# Bayside Planning Panel

Item No	6.1
Application Type	Development Application
Application Number	DA-2017/199
Lodgement Date	5 December 2016
Property	205-207 President Avenue, Monterey
Owner	Mr Johny Papantoniou
Applicant	MacGillivray Architects
Proposal	Construction of a four (4) storey residential flat building development, comprising 16 residential units, basement parking, front fence and demolition of existing structures
No. of Submissions	Two (2) in opposition; one (1) in support
Cost of Development	\$ 4,711,892.00
Report by	Brendon Clendenning, Creative Planning Solutions Pty Limited Pascal van de Walle, Coordinator Development Assessment

# **BAYSIDE COUNCIL** Delegated Planning Assessment Report

Application Number:	DA-2017/199	
Date of Receipt:	5 December 2016	
Property:	205-207 President Avenue, MONTEREY NSW 2217	
Lot & DP/SP No:	Lot A and Lot B in DP 421111	
Owner:	Mr Johny Papantoniou	
Applicant:	MacGillivray Architects	
Proposal:	Construction of a four (4) storey residential flat building development, comprising 16 residential units, basement parking, front fence and demolition of existing structures	
Value:	\$4,711,892	
Recommendation:	Refusal	
No. of submissions:	Two

Figure 3 Basement Floor Plan showing (from centre) the structural root zone, canopy spread, and tree protection zone, of the existing Jacaranda mimosifolia (MacGillivray Architects, 2017)

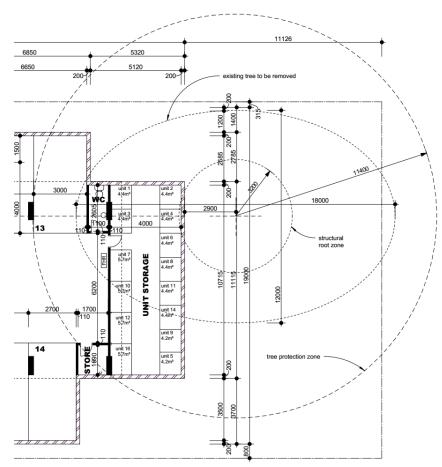
During a meeting with the applicant, Council indicated that there were other design options which would allow for the retention of the tree. The image below provides an excerpt of the amended basement floor plan. The basement floor plan shows that the basement storage provides a major incursion into the tree protection zone and the tree canopy.

The ADG indicates that at least half of the required apartment storage is to be provided within each individual unit, and allows for some storage to be provided within the basement. However, the ADG does not stipulate any minimum amount of storage that must be provided within the basement.

Figure 5 Ground Floor Plan showing (from centre) the structural root zone, canopy spread, and tree protection zone, of the existing Jacaranda mimosifolia (MacGillivray Architects, 2017)

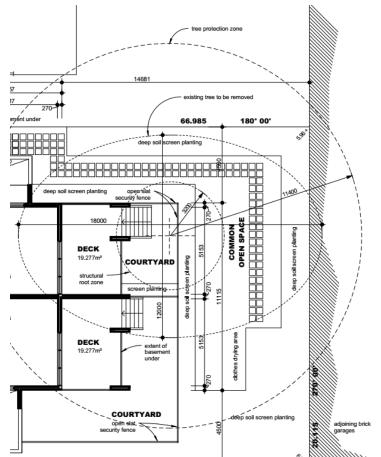
Finally, as shown within the image below, the ground floor courtyard areas of the rear units, are primarily comprised of hard stand areas, which are elevated above ground level, as a consequence of the limited depth of the basement (discussed further throughout the report). Although larger courtyard areas are favourable for ground floor units, within the context of the existing tree, every effort should be made to provide deep soil area surrounding the tree. For instance, it is possible to delete the lower level of the rear courtyards, as they are not required for to achieve minimum private open space requirements. It is not considered that this requirement is incompatible with the provision of suitable courtyard areas for the rear ground floor units.

It is evident that there are opportunities to shift the core of the building towards President Avenue and increase the rear setback to minimise the incursion on the tree. This information was communicated to the applicant as follows:
